Docket Item #12
DEVELOPMENT SPECIAL USE PERMIT #2003-0006
MAURY SCHOOL ADDITION

Planning Commission Meeting
April 6, 2004

ISSUE: Consideration of a request for a development special use permit, with site plan, for renovations and expansion of Maury Elementary School.

Second-story Option

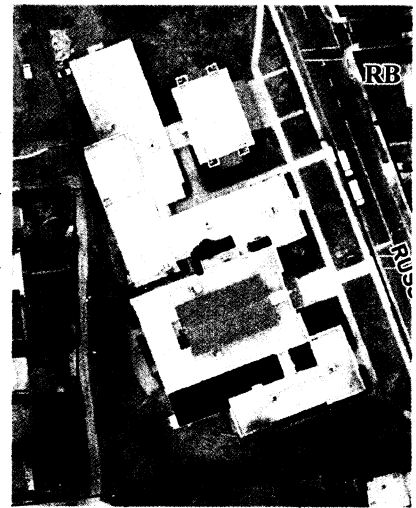
The applicant considered construction of a second story addition over the north portion of the building because that option would not increase impervious surface on the site and would minimally disrupt school operations during construction. However, this option would have created new classrooms that would be physically separated from the majority of the school space, exacerbating internal circulation problems that the school intends to improve with construction of the proposed plan. Staff was also concerned about the potential negative impacts that a second story addition would have on the surrounding single-family residences. Therefore, the applicant, the City and the community agreed that a one story addition, located in a way to minimize its impact on the community and open space, was the most viable option.

Preserve Existing Historic Structure

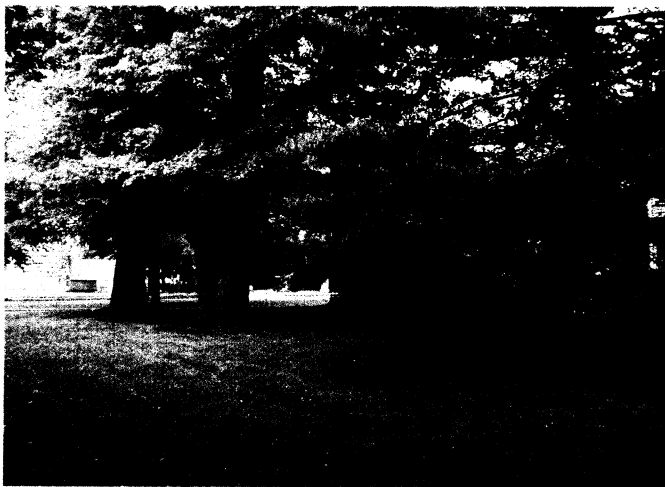
Staff is recommending that the school retain and repair as necessary the existing slate roof on the main building and portico. Staff supports the proposed renovations to the school with the exception of the optional proposal to remove the existing slate shingles from the main historic building and re-roof with asphalt shingles. This roof is visible to the public from the surrounding right-of-way and highlights the quality and character of the original school and neighborhood.

Early in the review process, staff expressed the desire and concern of the City and the Rosemont community that any renovations to the school should respect the existing school, which was constructed in 1929, and is a contributing structure in the Rosemont National Register Historic District. The applicant has worked with staff to preserve in place most of the existing structure, encapsulating existing exterior walls as new interior walls. Furthermore, the applicant has agreed to use a similar window pattern and brick as the existing school.

14. The existing slate roof on the historic portion of the school building that is a contributing structure within the Rosemont National Register Historic District shall be retained. If a new roof is required, re-roof using historically appropriate material such as slate or faux slate or comparable material to the satisfaction of the Director of P&Z to retain the quality and character of the existing school. (P&Z)
